UNITED STATES
DEPARTMENT OF THE INTERIOR
BUREAU OF LAND MANAGEMENTFORM APPROVED
OMB NO. 1004-0135
Expires: July 31, 2010**SUNDRY NOTICES AND REPORTS ON WELLS**
*Do not use this form for proposals to drill or to re-enter an abandoned well. Use form 3160-3 (APD) for such proposals.***SUBMIT IN TRIPLICATE - Other instructions on reverse side.**

OXY USA Inc. respectfully requests approval for the following changes to the drilling plan:

API Number 30-015-42030	Pool Code 77494	Pool Name Cottonwood Draw Bone Springs
Property Code 39207	Property Name PEACHES "19" FEDERAL	Well Number 4H
OGRID No. 16696	Operator Name OXY USA INC.	Elevation 3222.9'

Peaches 19 Fed 4H
Eddy County, NM (NAD 27 NME)
Northing: 408156.30
Easting: 530338.30
Plan #1

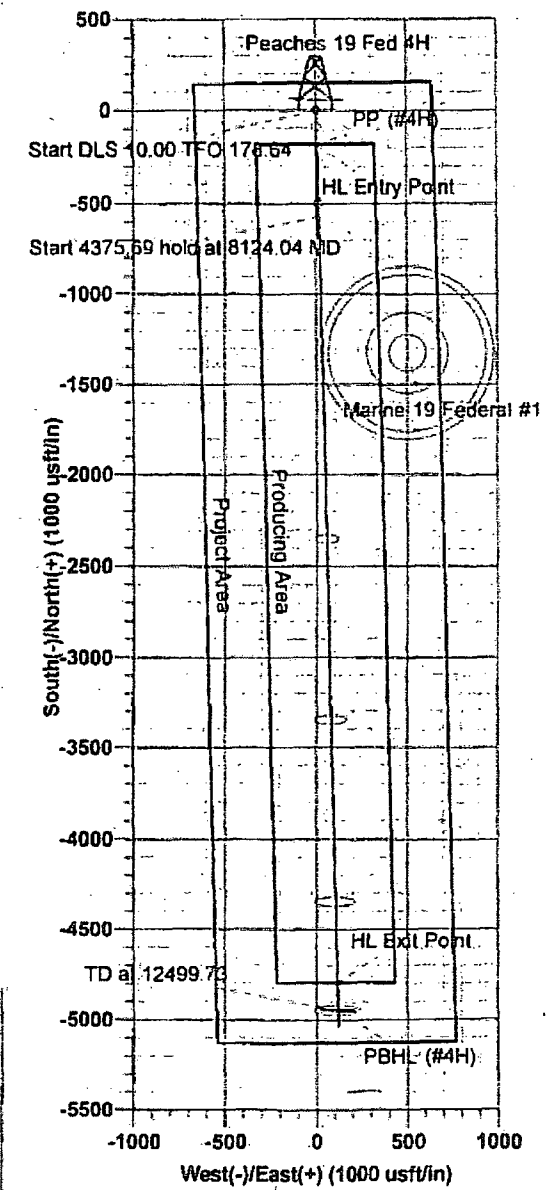
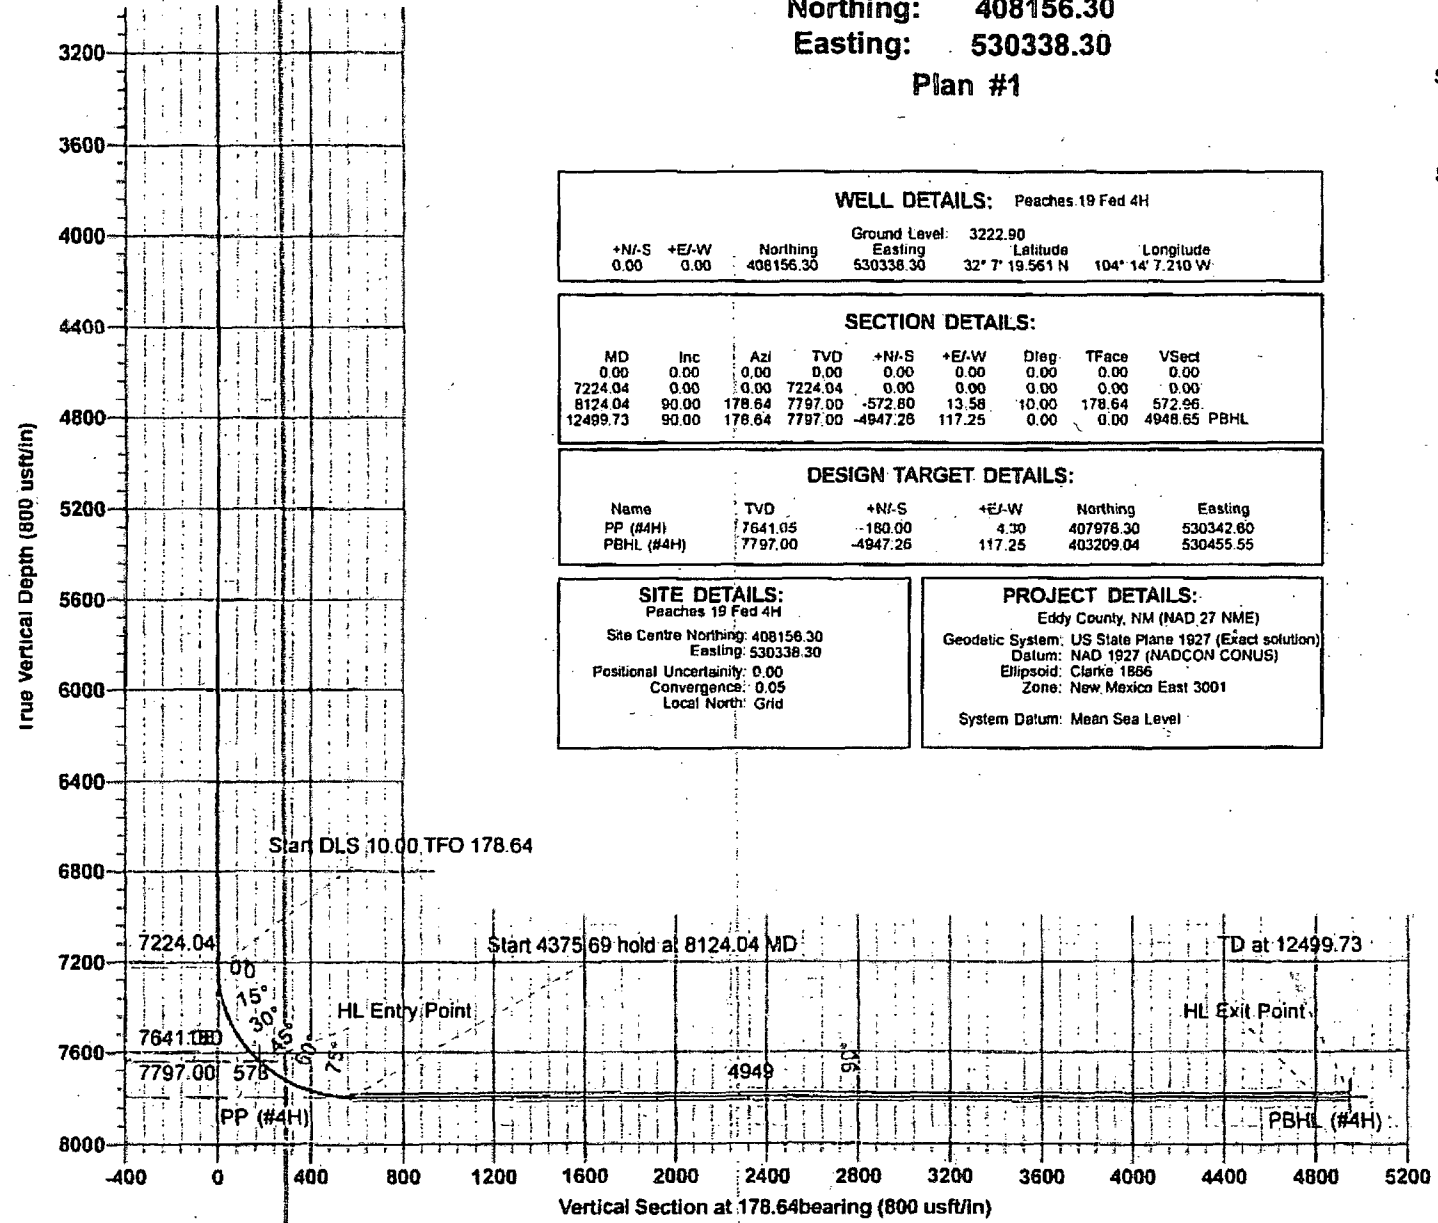
1. Extend the BHL approximately 150' past the south hardline to allow for our shoe track and perforating guns, see attached for amended C-102 plat and amended directional drilling plan.

2. Adjust production casing and cementing to amended TMD.

Proposed TD - 12500'M 7797"V

Production Casing
5-1/2" 17# L-80 BT&C new csg @ 0-12500'M, 7-7/8" hole w/ 9.2# mudBDS 8/12/15
Accepted for record
NMOCD
